NOTICE OF NON-PERFORMANCE

INSPECTION REPORT

Electrical Corporation:	Southern California Edison Company
Report Number:	PAD_SCE_YLO_20260617_0957
Inspector:	Yana Loginova
WMP Year Inspected:	2025
Quarterly Data Report (QDR) Referenced:	Quarter 4 (Q4)
Inspection Selection:	Energy Safety viewed the contents of the Q4 QDR and performed an analysis that resulted in the selection of the WMP initiatives and locations referenced in this report.
Relevant WMP Initiative(s):	8.1.3.1 - Distribution Detailed Inspections and Remediations (IN-1.1)
Date of Inspection:	June 17, 2026
City and/or County of Inspection:	Corona, San Bernardino County
Inspection Purpose:	Assess the accuracy of Southern California Edison Company’s QDR data, completeness of its work, and performance of WMP requirements.

General Image 1: Overall Structure

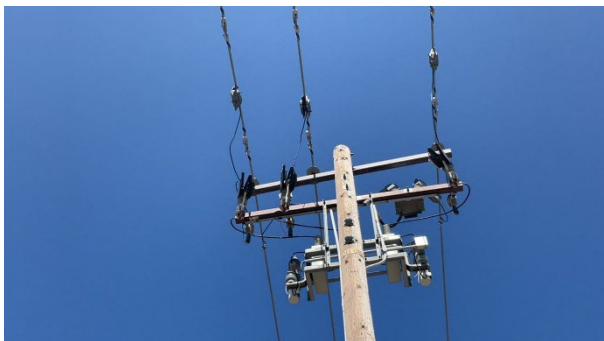
In the 2025 Q4 Quarterly Data Report Submission, Southern California Edison Company reported that work on Distribution Remediation was completed at Structure ID 4739126E, Grid Hardening ID 414445064-4739126E at 16876-16898 Chino Corona Rd, Corona, CA, 92880, 33.9461581785984, -117.634253792228. At this location, the inspector observed that the tap cover was unsecured. The inspector's observation is documented in Deficiency 1 photographs, which are attachments to this report. Photo numbers Asset Image 1, Asset Image 2, Asset Image 3, depict unsecured tap cover.

1. Southern California Edison Company's 2025 Q4 Quarterly Data Report Submission reported that work related to 2025 WMP initiative number 8.1.3.1 Distribution Detailed Inspections and Remediations was complete at this location.
2. The original notification at issue at this location identified that remediation of missing avian protection on fuse and center phase bare tap cover was required.
3. Although the work was reported as complete by SCE, the inspector observed that the tap cover was unsecured upon inspection.

Deficiency 1. Energy Safety observed that in implementing 2025 WMP initiative 8.1.3.1 - Distribution High Fire Risk-Informed (HFRI) Inspections and Remediations (IN-1.1), SCE failed to complete remediation of missing tap cover on Structure ID 4739126E, Grid Hardening ID 414445064-4739126E at coordinates 33.9461581785984, -117.634253792228. Energy Safety considers this non-performance to be in the Minor risk category. SCE must complete a corrective action for this deficiency by 12 months from the date of this notice.¹
